Project	IEEE 802.16 Broadband Wireless Access Working Group < http://ieee802.org/16 >		
Title	MBS AES-CTR Test Vector and Test Program Changes Rev 1		
Date Submitted	2005-03-17		
Source(s)	JUNHYUK SONG, JICHEOL LEE, YONG CHANG Samsung Electronics	Voice: +82-31-279-3639 junhyuk.song@samsung.com	
	Zohar, ilan Intel		ilan.zohar@intel.com
Re:			
Abstract	MBS AES-CTR Test Vector		
Purpose	Per C802.16e-05/047r1, MBS AES-CTR Test Vector and figure change		
Notice	This document has been prepared to assist IEEE 802.16. It is offered as a basis for discussion and is not binding on the contributing individual(s) or organization(s). The material in this document is subject to change in form and content after further study. The contributor(s) reserve(s) the right to add, amend or withdraw material contained herein.		
Release	The contributor grants a free, irrevocable license to the IEEE to incorporate material contained in this contribution, and any modifications thereof, in the creation of an IEEE Standards publication; to copyright in the IEEE's name any IEEE Standards publication even though it may include portions of this contribution; and at the IEEE's sole discretion to permit others to r

Figure 137a—MBS MAC PDU Ciphertext Payload Format

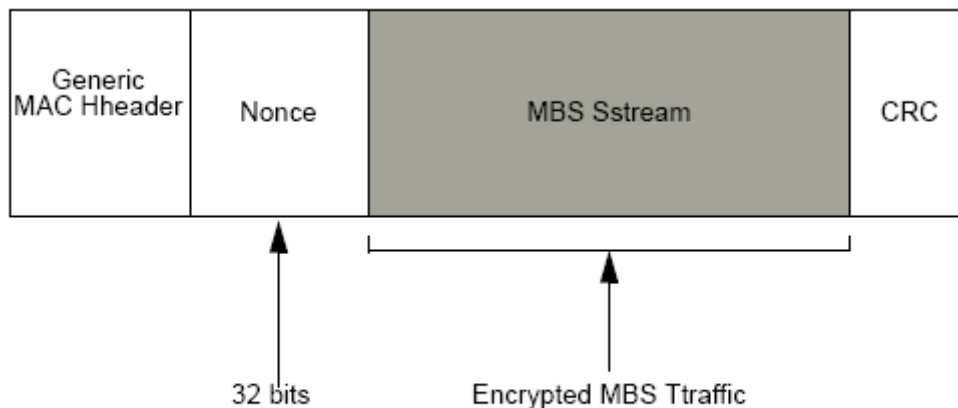
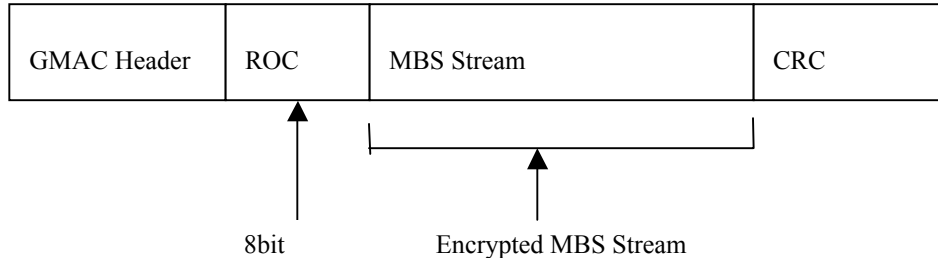
1. Figure 137a MBS MAC PDU Ciphertext payload format
2. MBS AES-CTR Test Vector and test program
3. Clarifying the text including note about ROC

[Change Figure 137a.]

The PDU payload for AES-CTR encryption shall be prepended with the 8-bit ROC, i.e., the ROC is the 8 MSBs of the 32 bit nonce. The ROC shall be transmitted in little endian order. The ROC shall not be encrypted.

The processing yields a payload that is 8 bits longer than the plaintext payload.
